CITY OF ALBUQUERQUE

October 24, 2018

**Re: Mesa Del Sol Montage Unit 3B
Grading and Drainage Plan Engineer's Stamp dated: 8/29/2018, Drainage
Report Engineer's Stamp dated 4/25/2014 (R16D006)**

MESA DEL SOL NEIGHBORHOOD MONTAGE UNITS 3 & 4 DEVELOPED CONDITIONS UPDATED BASIN MAP 10/2018

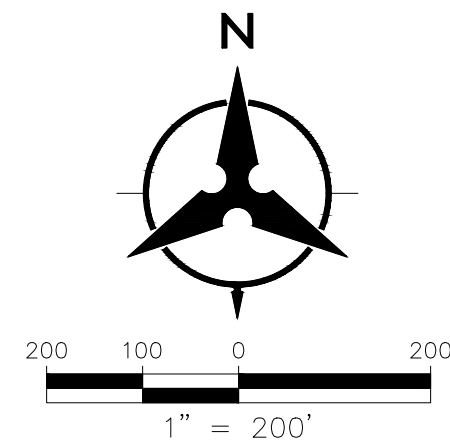
1. An Erosion and Sediment Control Plan must be submitted to Stormwater Quality prior to approval for Grading Permit.
2. The revised hydrology calculations shown on the updated Basin Map must be stamped and signed by a professional engineer licensed in the state of New Mexico.

3. The pond volume summary on the revised Basin Map is not adequate for review. Since this plan is revising the previous design of the ponds, a complete presentation of all related calculations is required. Detailed pond volume calculations are required including hydrology calculations and basin maps of all areas that drain to the ponds and volume calculations that show the area of each contour and the associated volume calculated using the conic equation. Show all pipes connecting to the ponds and provide HGL calculations for the pipes. Label 100-year water surface elevations and associated volumes of the ponds. Additional pond comments may be forthcoming after the design calculations are provided.

CITY OF ALBUQUERQUE	
		PUBLIC WORKS DEPARTMENT	
MESA DEL SOL MONTAGE UNIT 3B			
GRADING AND DRAINAGE PLAN			
Design Review Committee	City Engineer Approval	Mo./Day/Yr.	Mo./Day/Yr.
City Project No.	Zone Map No.	Sheet	Of
	R-15,16 S-15,16	2	6

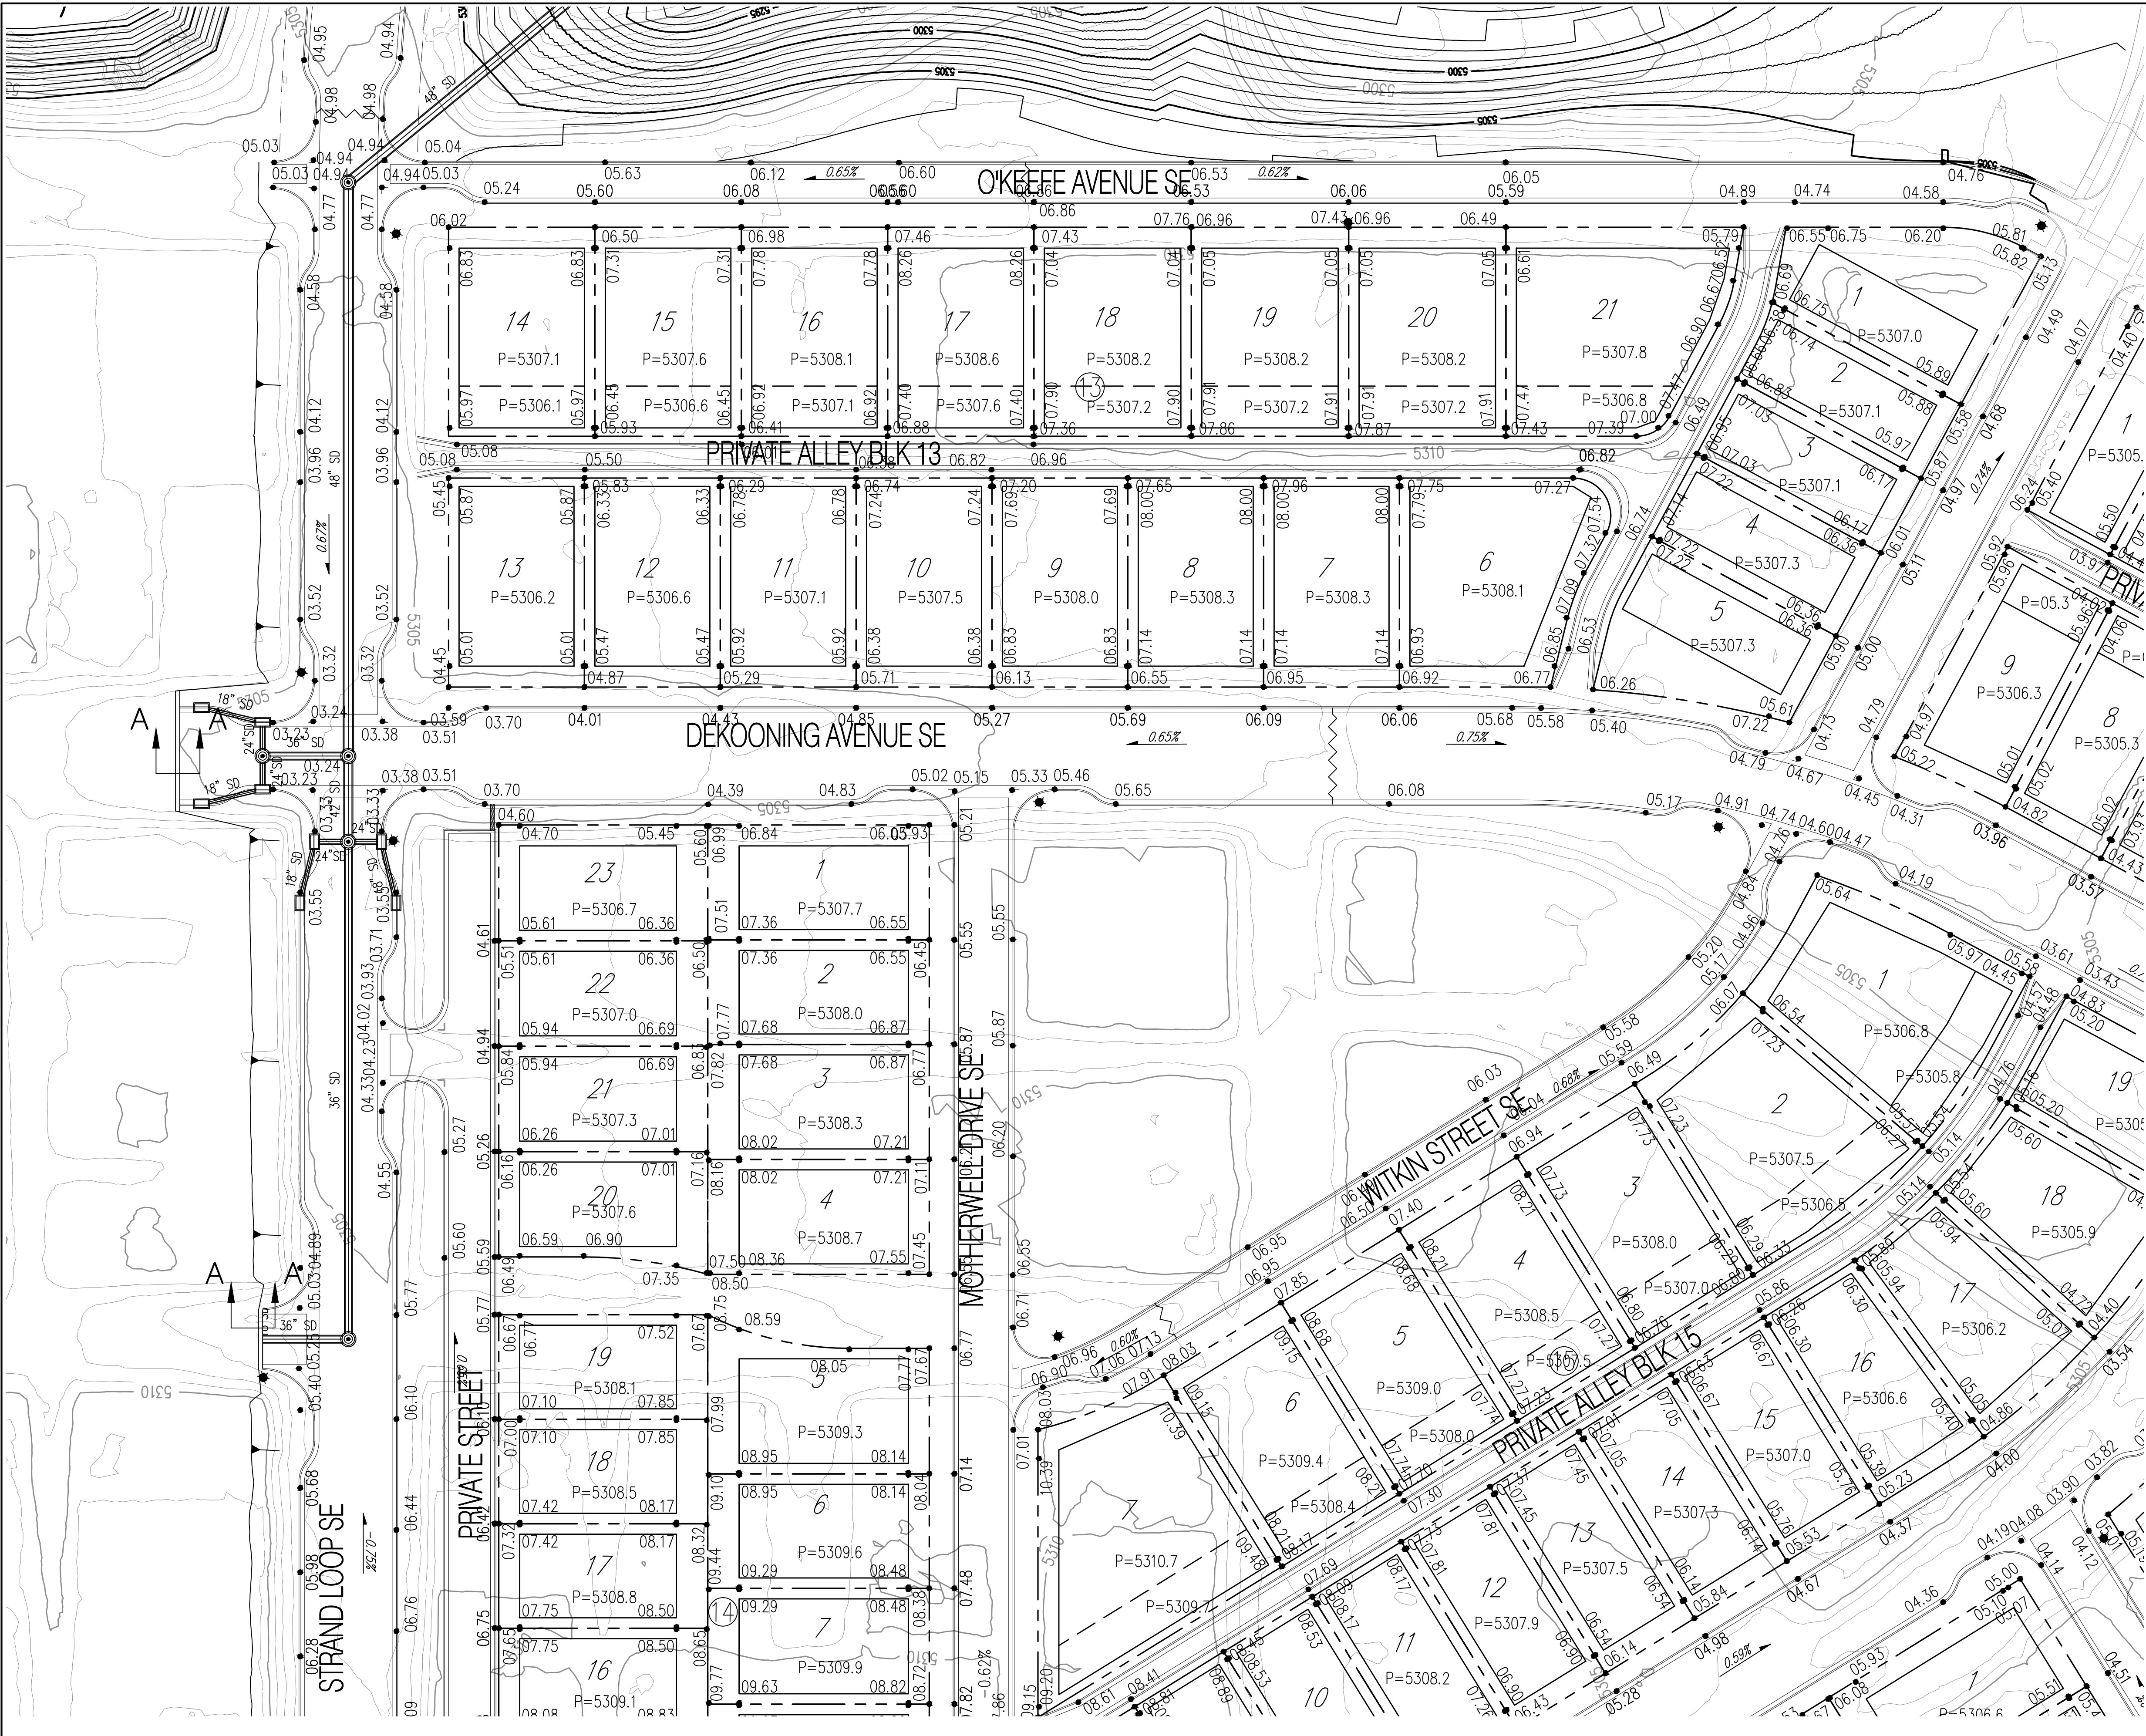
11. Several spot elevations on sheet 2 appear to be incongruous with the surrounding elevations:
 - a. Elevation 07.22 on the south side of Lot 5 Block 13 is 18" higher than the adjacent lot and street grades.

- b. Elevation 04.97 on the west corner of Lot 9 Block 12 is about half of a foot low relative to the adjacent street grades
 - c. Elevation 04.01 on the east corner of Lot 6 Block 12 is 3.5' higher than the adjacent street.

- d. Elevation 01.64 on the south corner of Lot 6 Block 12 is 18" lower than the adjacent lot and street grades.
 - e. Elevation 05.58 on the east corner of Lot 1 Block 15 is one foot too high relative to the adjacent lot and street grades.

Design Review Committee	City Engineer Approval	Last Design Update	Mo./Day/Yr.	Mo./Day/Yr.
City Project No.		Zone Map No.	Sheet	Of
		R-15,16 S-15,16	3	6

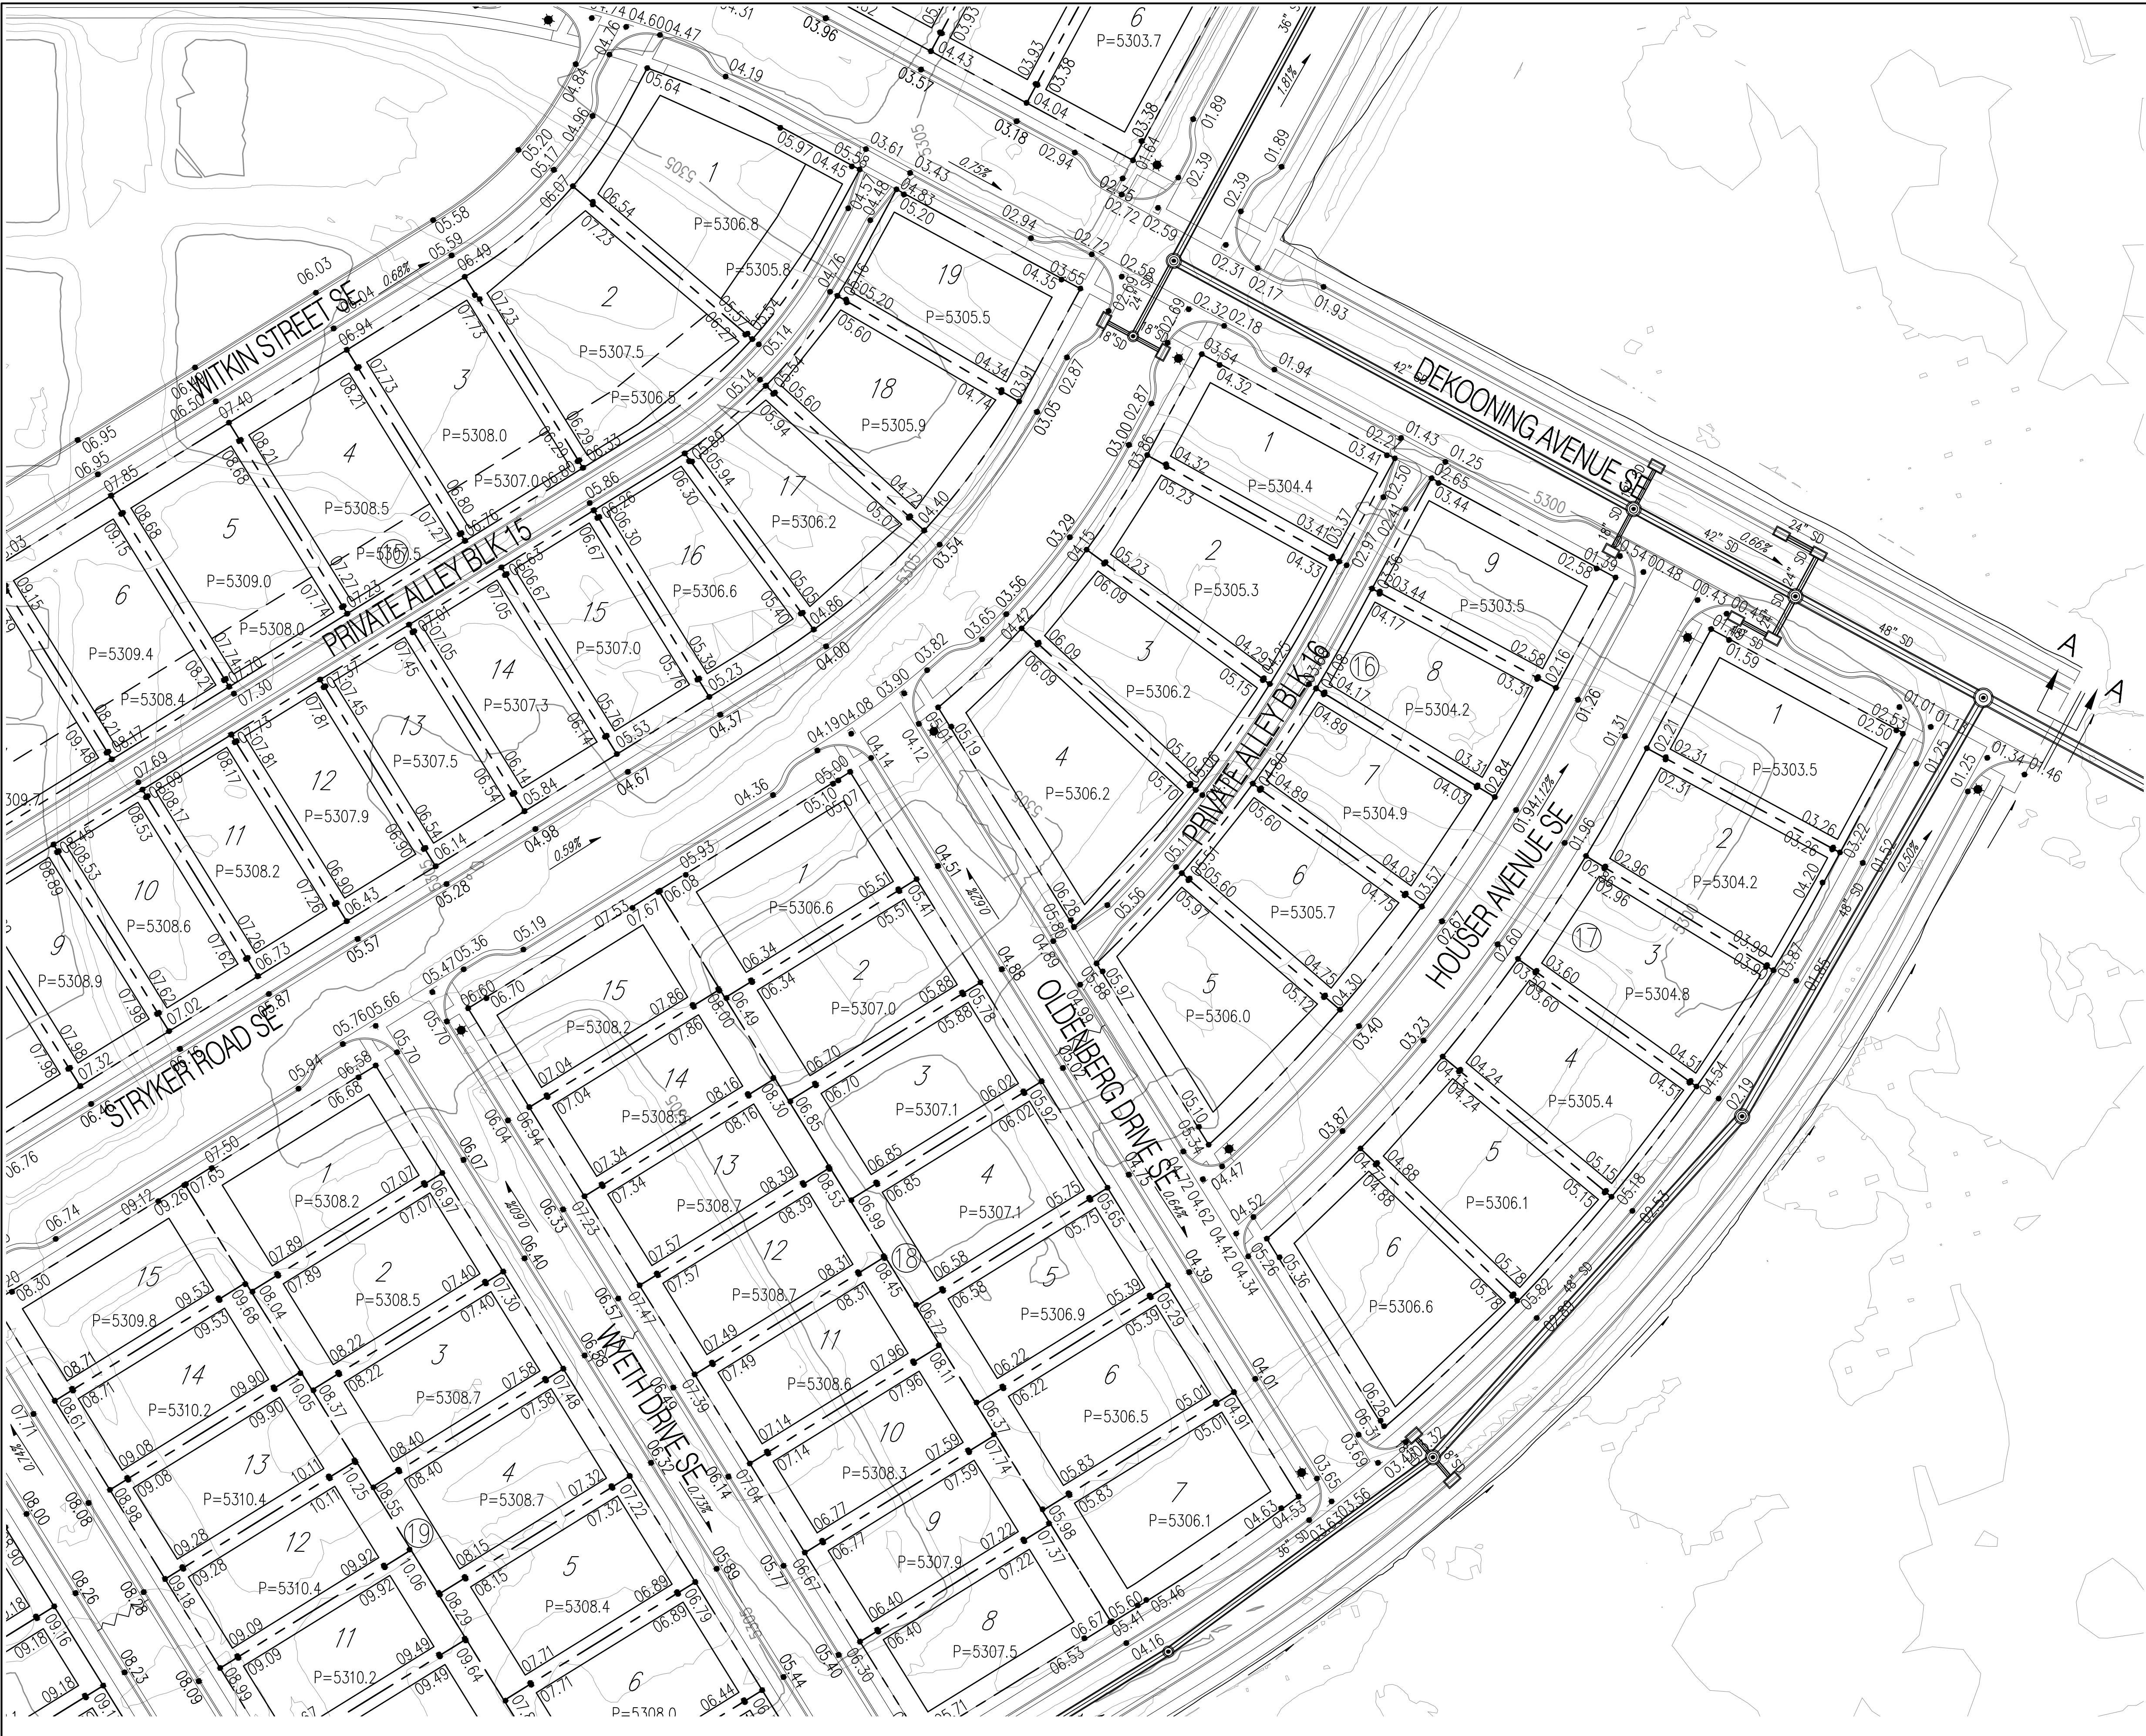
9. Add the standard private maintenance note to the preliminary plat note regarding the drainage easement on the alleys.
10. More grading detail is needed on the interface between the alleys, the streets, and the lots. For example the side yard swale elevations at the rear of lot 9 block 12 and the right of way elevation of Witkin Street next to lot 9 is about 0.5' higher than the pad, and the pad is about 1.3' higher than the adjacent grade in the alley which seems to indicate that some drainage is going to the alley. Show the sidewalks on sheet 3
